Region 9 Enforcement Division
75 Hawthorne Street
San Francisco, CA 94105

Inspection Date(s):	9/30/15		
Time:	**Entry:** 1:00pm	**Exit:** 2:15pm	
Media:	Water		
Regulatory Program(s)	Clean Water Act NPDES /CAFO Dairy		
Company Name:	TIVA Dairy		
Facility or Site Name:			
Facility/Site Physical Location:	Ex. 6 Personal Privacy (PP)		
Geographic Coordinates:			
Mailing address:			
Facility/Site Contact:	Dickie Vander Meulen	**Title**: Owner/Operator	
	Phone: Ex. 6 Personal Privacy (PP)	**Email**:	
Facility/Site Identifier:	NPDES CAG018001 / Order R8-2013-0001, General waste discharge requirements for CAFOs (dairies and related facilities)		
NAICS:	112120 Dairy Cattle and Milk Production		
SIC:	0241 Dairy Farms		
Facility/Site Personnel Participating in Inspection:			
Name	Affiliation	Title	Email
Dickie Vander Meulen	TIVA Dairy	Operator	
EPA Inspector(s):			
John Tinger	EPA	Engineer	Tinger.John@EPA.gov
Federal/State/Tribal/Local Representatives:			
Edward Kashak	WRCB-R8	Engineering Geologist	ekashak@waterboards.ca.gov

SECTION I – INTRODUCTION

The facility has obtained coverage under NPDES CAG018001 / Order R8-2013-0001, General waste discharge requirements for CAFOs (dairies and re

Photo 8 : Ditch and berm along eastern edge of facility. View looking North.

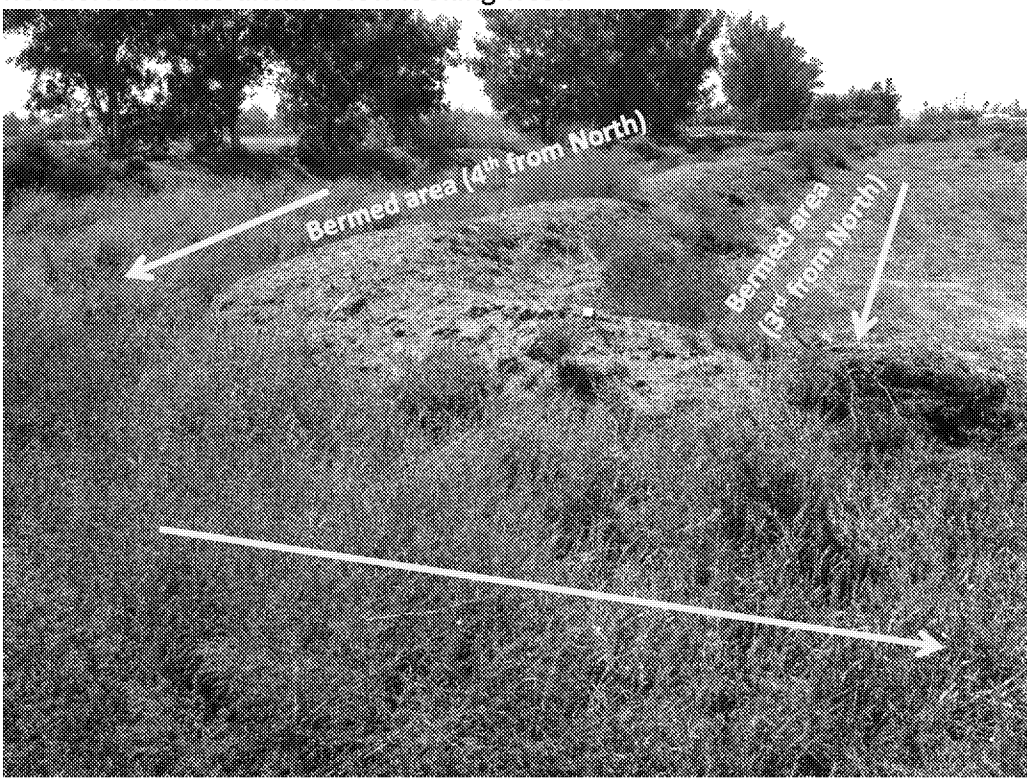
At the eastern end of the bermed areas, the berms are several feet lower to create a spillway into a ditch running alongside the eastern boundary (photo 8). The ditch was observed to contain heavy vegetation cover, especially in the southeast corner. The ditch directs wastewater northward back towards the center of the facility. At the end of the ditch, the operator has installed a pump (photo 10). When the ditch is full, the operator pumps wastewater to the northernmost disposal area where it infiltrates (photo 11). Excess wastewater from this pasture area may overflow to the center disposal area (photo 12).

- The ditch on the eastern border of the facility appeared to have excessive vegetation.

Exterior berms appeared to be properly constructed. No rodent holes observed, minimal vegetation along tops of berms. Excess vegetation observed in ditches alongside berm.

Photo 12: disposal area in center of eastern section of facility. This area receives stormwater flow from corrals, and receives any overflow from the disposal area in photo 11. The area is disked to promote infiltration. View looking northwest.

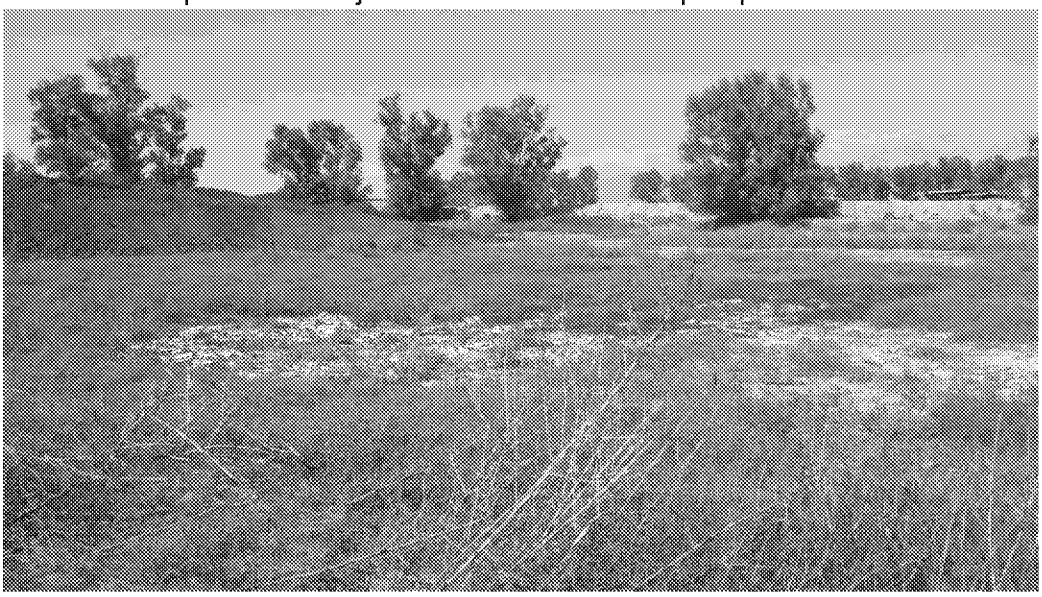
Stormwater generally flows from the corrals towards the center and easterly direction to the disposal areas (photo 12). The soils in the disposal area were observed to be sandy and very porous. The operator noted the high percolation rates in this area, and stating that 2' of water will drain overnight. The operator rips the disposal area as needed to encourage infiltration in this area. The operator recently bought a new disc ripper to facilitate ripping the area.
